UNITED STATES PATENT AND TRADEMARK OFFICE

APPLICATION NO.	FILING DATE	FIRST NAMED INVENTOR	ATTORNEY DOCKET NO.	CONFIRMATION NO.
09/729,743	12/06/2000	Steven B. Bridgers	P-5200-01-00	7935

<b>Office Action Summary</b>	Application No.	Applicant(s)	
	09/729,743	BRIDGERS, STEVEN B.	
	Examiner Michael P. Ferguson	Art Unit 3679

**FIG. 2A**

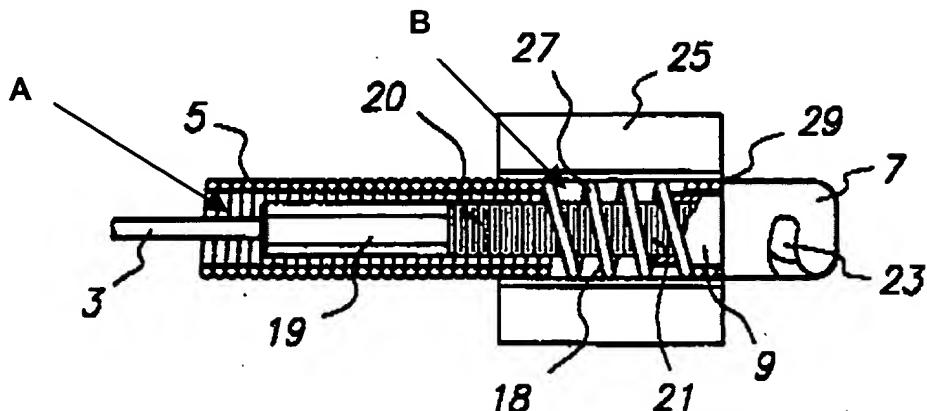
As to claim 9, McGaffigan discloses a connector system having a link member **5** and nodal members **25, 33** having operative cavities (**A, B**, respectively) intercommunicating at spring members **18** (cavity **A** in link member **5** and cavity **B** in nodal member **25** intercommunicate via tension cable assembly **3, 19, 20**; spring member **18** abutting the end surface of link member **5** and the interior surface of nodal member **25**; Figures 1A and 2A).

As to claim 10, McGaffigan discloses a connector system having actuating systems 3, 19, 20 deployed in cavities A, B, effective for selectively varying the effective length of a link member 5 (tension cable assembly 3, 19, 20 extends within cavity A in link member 5 and cavity B in nodal member 25; Figures 1- 6).

As to claim 11, McGaffigan discloses a connector system having nodal bodies 33 disposed in a three dimensional array (Figures 1A and 2A).

**FIG. 3A**

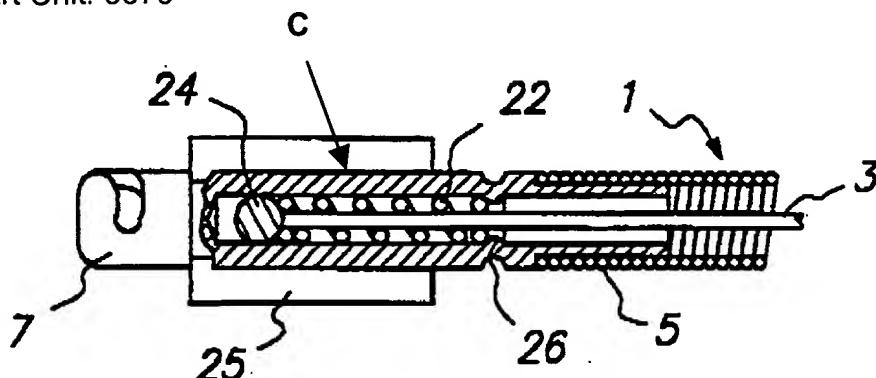
As to claim 15, McGaffigan discloses an internodal connector architecture system having:

a plurality of nodal body members 25, 33, each of the body members having a plurality of compliant strut members 1 attached thereto, each strut member including a spring member 22 adjacent the nodal member and an elongated hollow link member C, 5 connected to a link member C on an adjacent nodal member (Figure 3A).
